Sunwater
Supplementary Report
Queensland Competition Authority

RURAL IRRIGATION PRICING REVIEW 2025-29

Document title: Sunwater Supplementary Report

Figure 2-1 - Age profile of Sunwater workforce and comparators

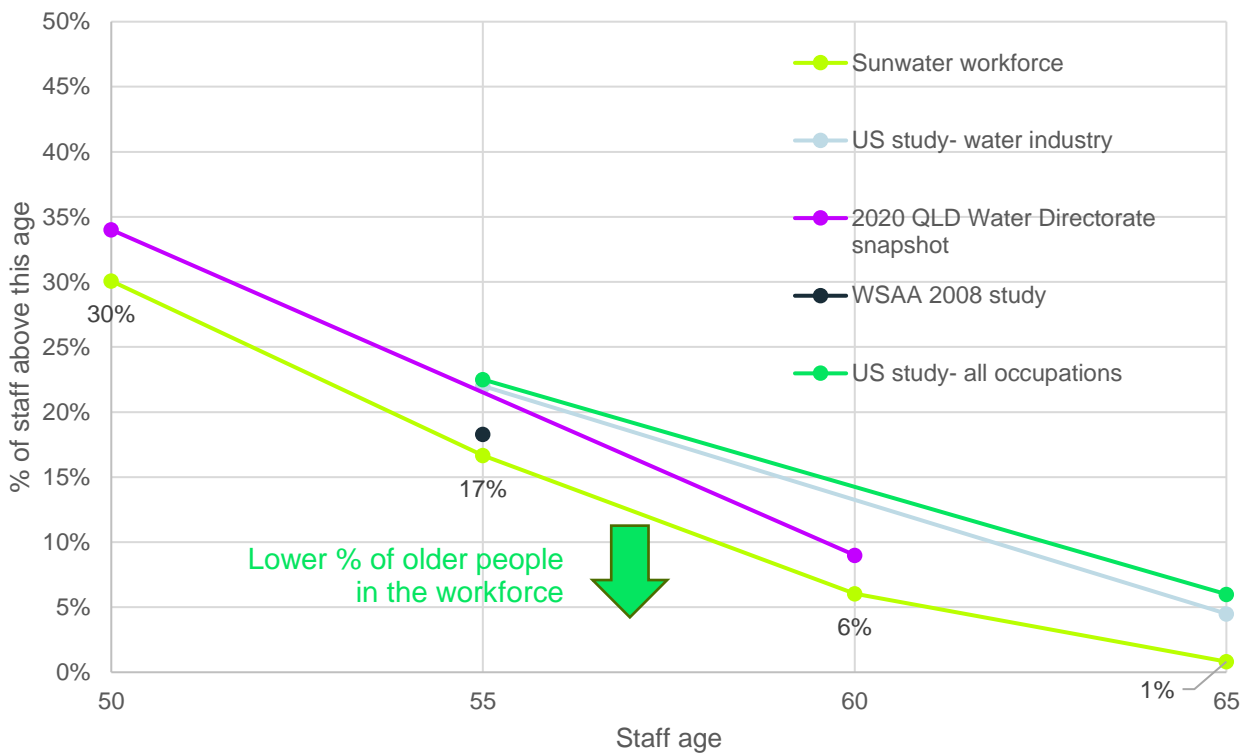
- The studies referenced in its response document suggest that Sunwater's workforce has a lower proportion of older staff than the comparators including the Queensland 2020 study and Australia level 2008 review. This is not supportive of Sunwater having more of, or even the same level of challenge, related to an ageing workforce compared to the wider sector.

We therefore conclude that we are not in a position to amend the direct labour costs recommended in our report as a result of Sunwater’s response about the ageing workforce.

Figure 2-3 - Utilisation rates

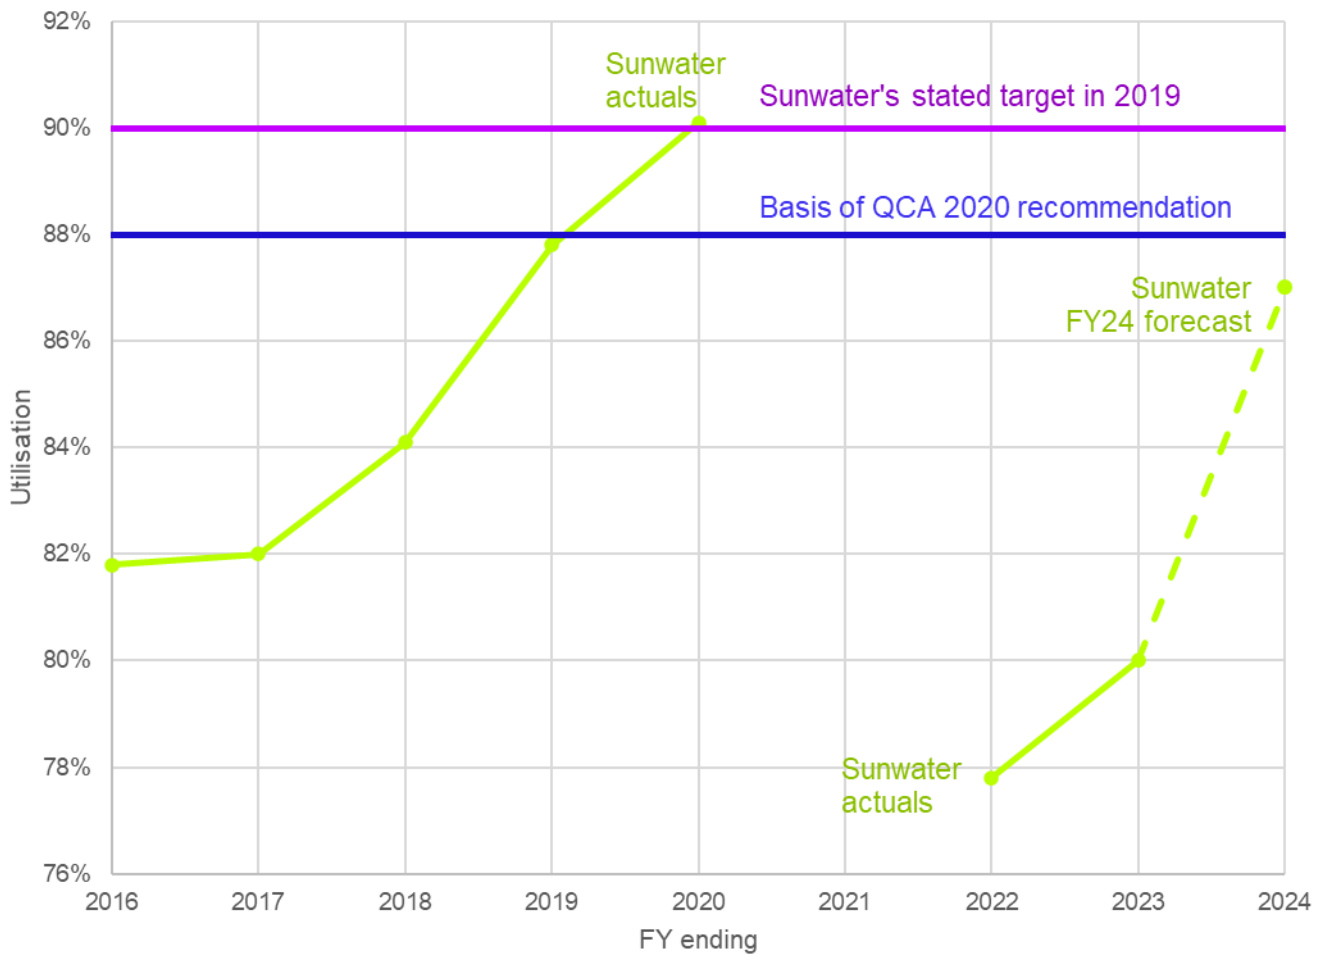
- Sunwater’s own projections (see Figure 2-3 below) are for utilisation to improve significantly in FY24, suggesting that the utilisation in the base year, FY23, is not as efficient as the FY24 projected level or FY18, 19 or 20 outturn levels. In this way, it appears that Sunwater’s own projection is supportive of the comments in our report.

We therefore find that we are not in a position to amend the direct labour costs recommended in our report as a result of Sunwater’s response about utilisation rates.

Figure 4-2 - Orion redeployment adjustment

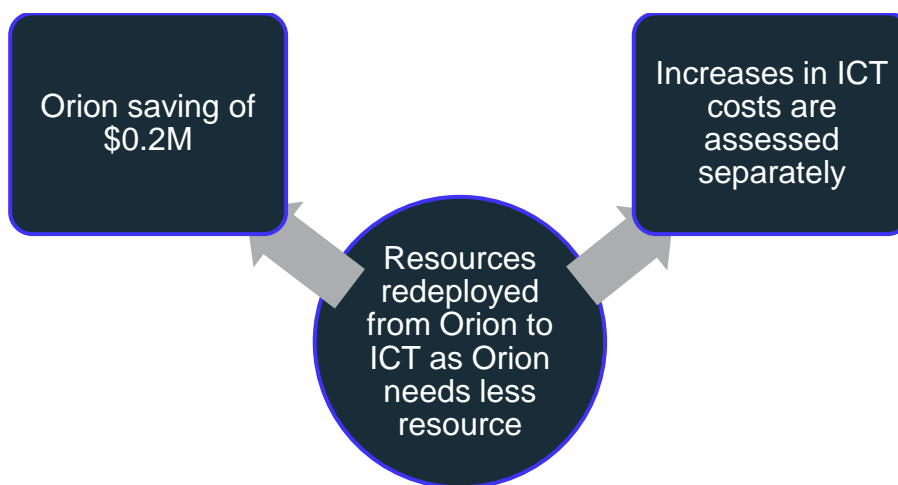
Irrespective of where the resources were redeployed to, the retirement of the Orion system has led to a saving of \$0.2M with resources deployed elsewhere. In its response Sunwater does not dispute that \$0.2M of costs has been removed from the Orion system.

To argue that the redeployed costs should not be netted off as an offsetting efficiency is effectively to argue that ICT costs should be increased by \$0.2M. This is illustrated by the thought-experiment of assuming that the \$0.2M of resource is redeployed to the ICT program but only used to deal with attrition in the ICT team. In this example, the costs of the Orion system (reduced by \$0.2M) and ICT costs (no change) reduce by \$0.2M overall. Hence the argument for redeployment not to be netted off is effectively an argument for increased ICT expenditure.

Figure 5-4 – Proportion of direct costs falling within each project size band

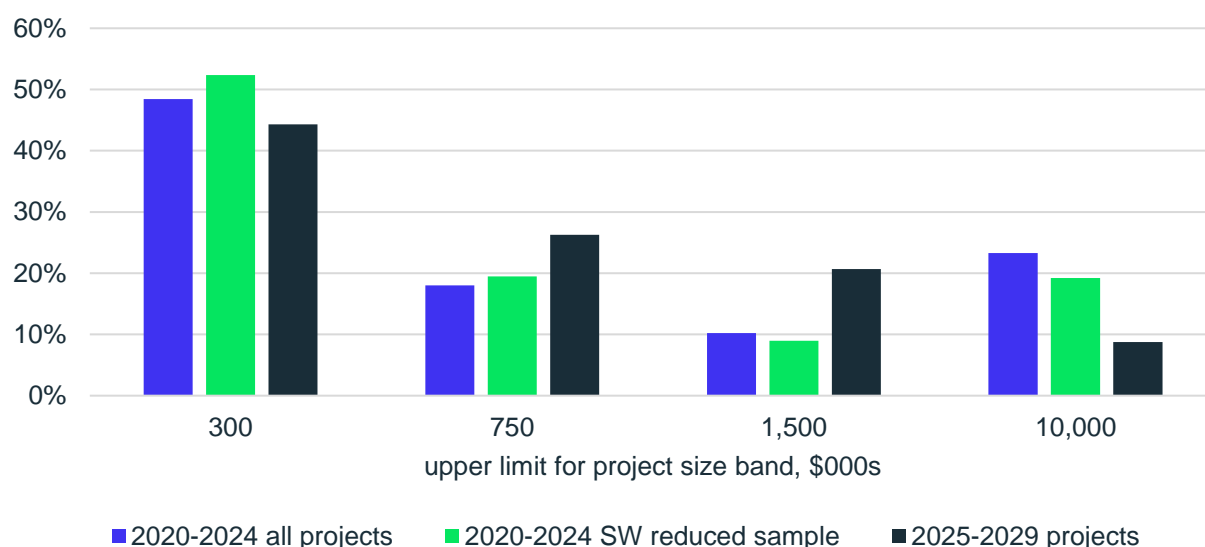
- Reviewing the data for historical and future renewals the project distribution does not show a marked increase in small projects between the future and historical projects (indeed it suggests a reduction). It also appears that the reduction in ‘very large’ projects is reflected by increases in large and medium sized projects as can be seen in Figure 5-4.

Figure 5-12 - Our understanding of the process used to evaluate the impact of the new policy

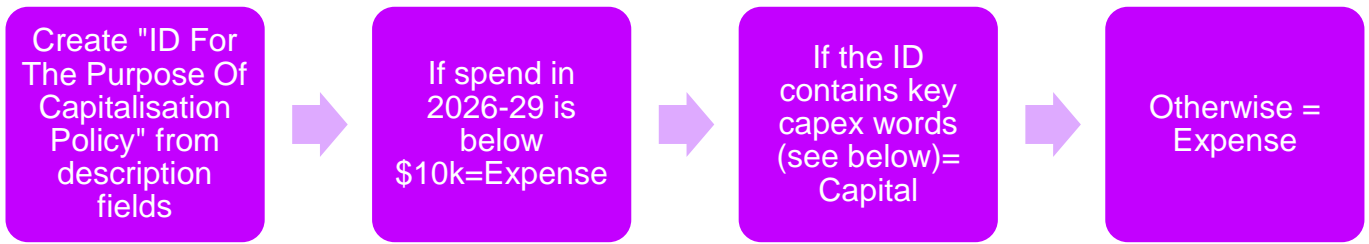
Our understanding of the logic used in assessing the impact of the change in policy is summarised below.

Figure 5-13 – Alternative approach used to test sensitivity test of the change in policy

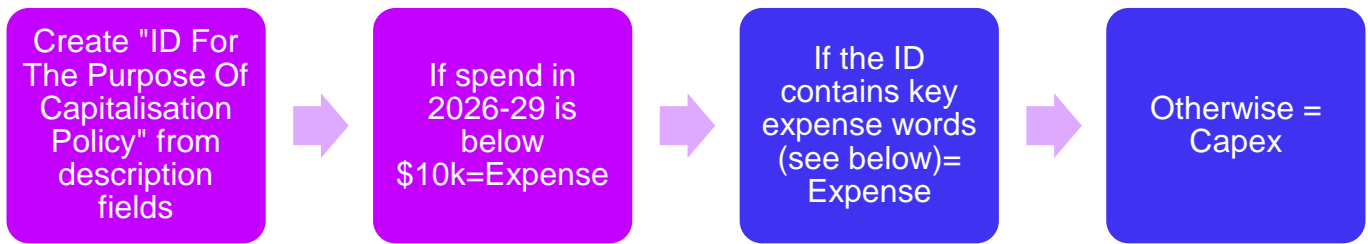
The results of doing the assessment in this order is that the % of expenditure which is expensed increases to c16%.
